Planning Commission

Regular Meeting Agenda

Thursday, April 11, 2013
7:00 p.m., Council Chambers

Agenda Item #7
Dockside Restaurant

Harbor Line
Idler 124'
10.5'
Aerial 2011

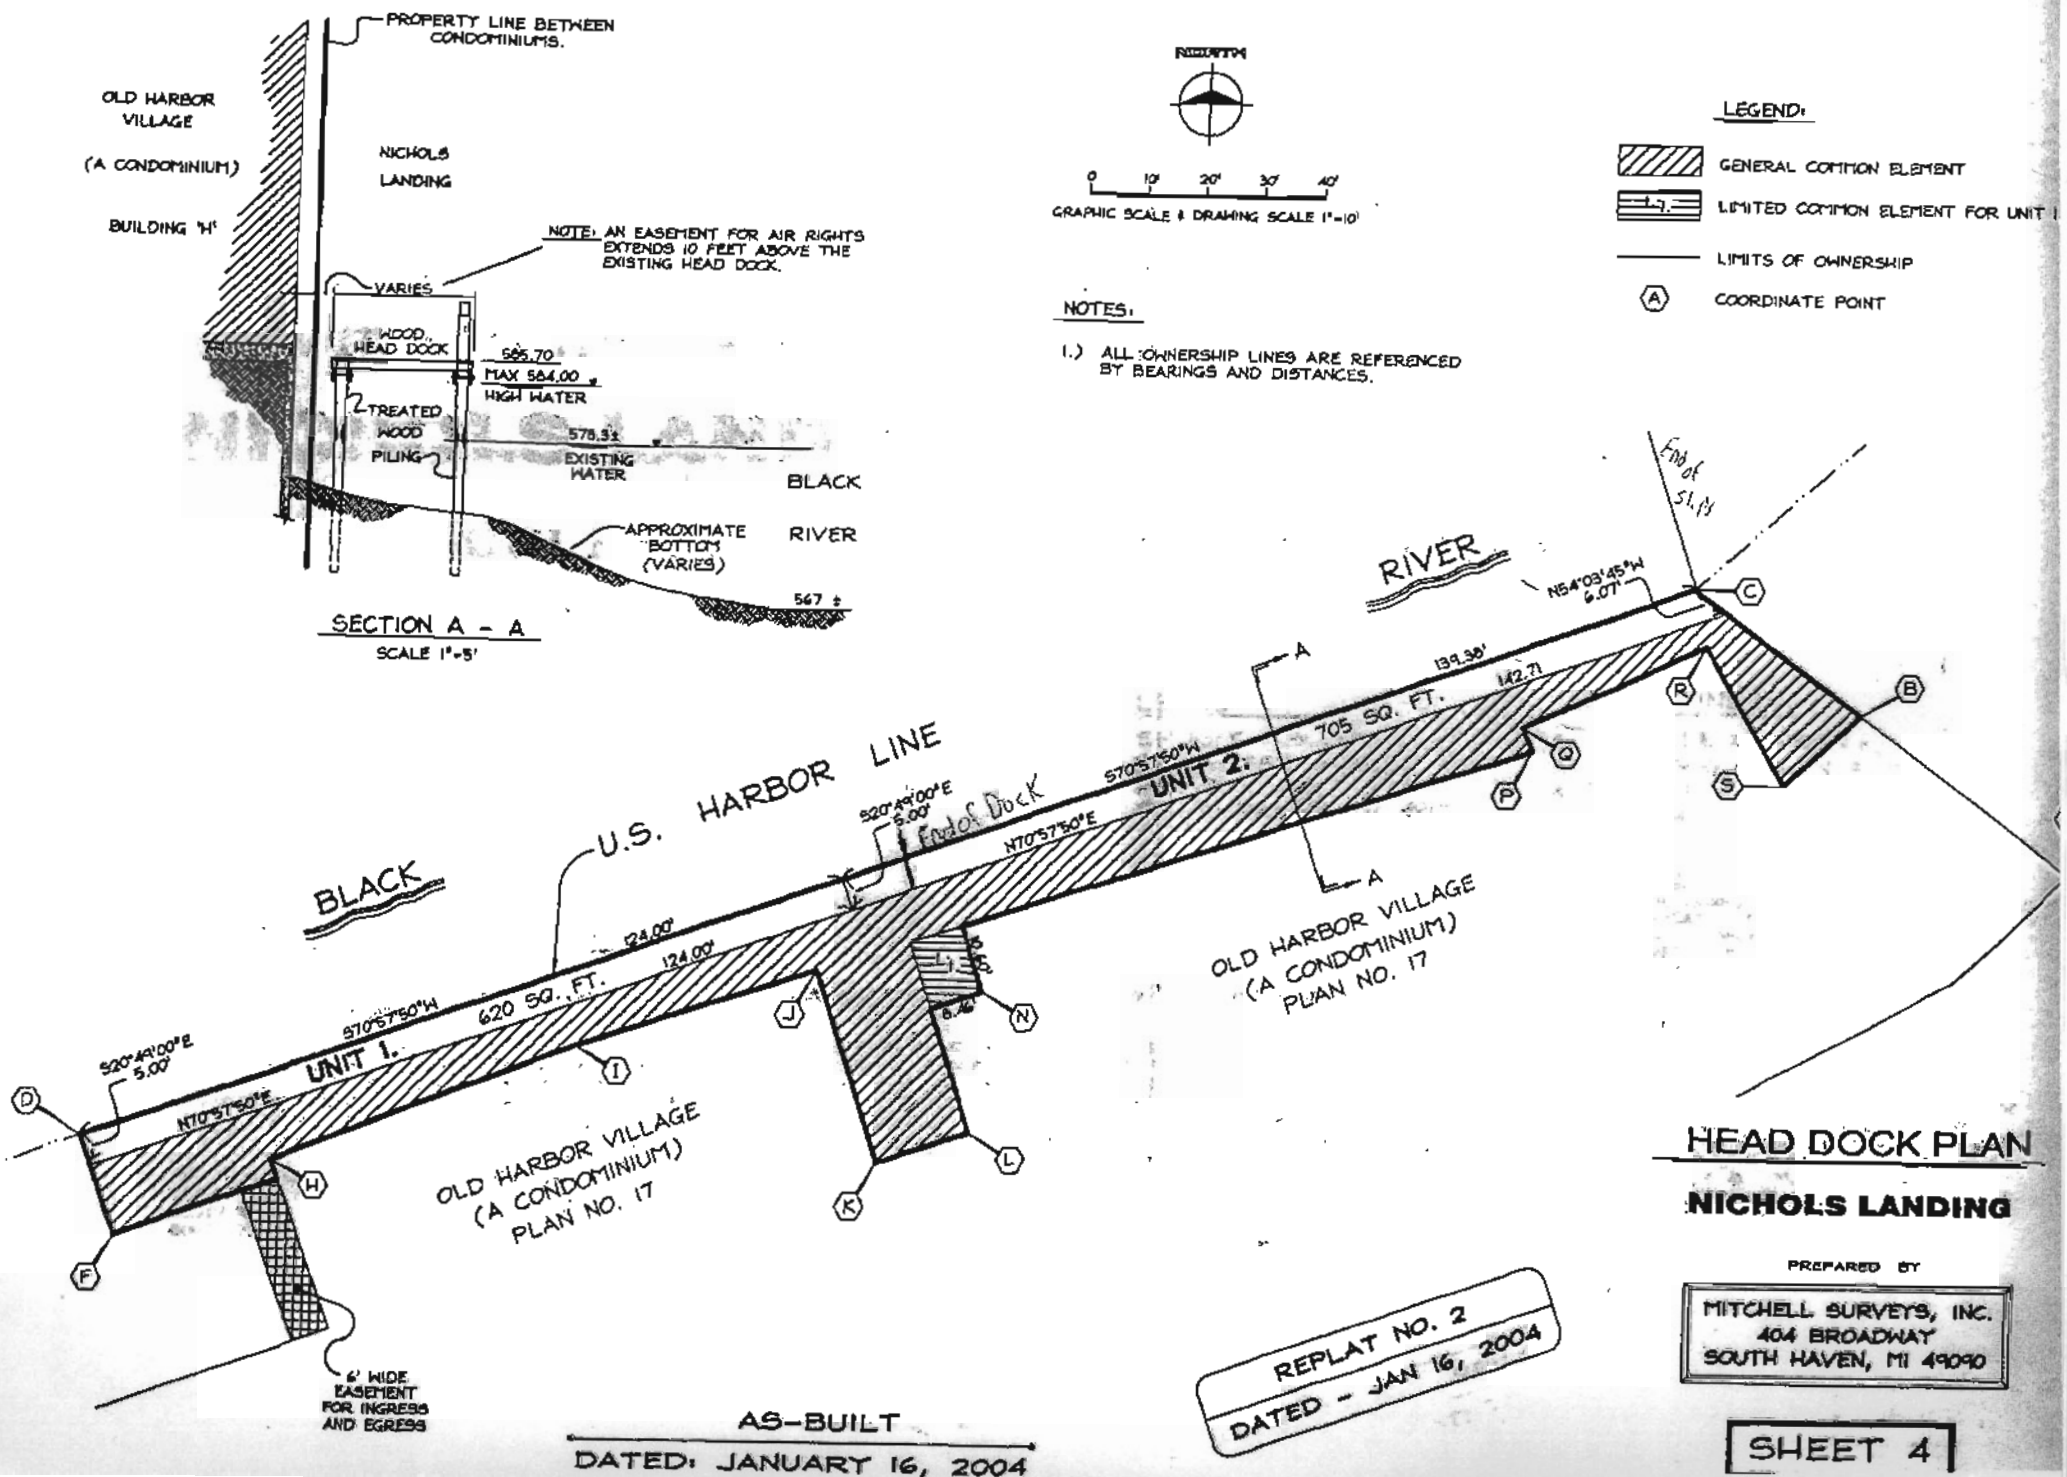
The South Haven Code of Ordinances prohibits construction of permanent dock structures on the river side of designated harbor lines. See the South Haven Code of Ordinances, Section 38-4(8).

The harbor line runs parallel to the dock about 10 feet into the river in the area of the Idler. (see attached sketch). It is unlikely that a dock which extends past the harbor line would be permitted.

Vessels are permitted to moor and extend past the harbor lines. Vessels are not permitted to obstruct harbor traffic. See the South Haven Code of Ordinances, Section 38-4(3).

I am not sure how the approval process would work with a vessel that is constructed to remain in place (substantially a land structure). It may require a review by the Coast Guard, Army Corps of Engineers, DNR, Fire Marshal, Harbor Commission and/or the City. In order to determine the approval path, more detail is needed.
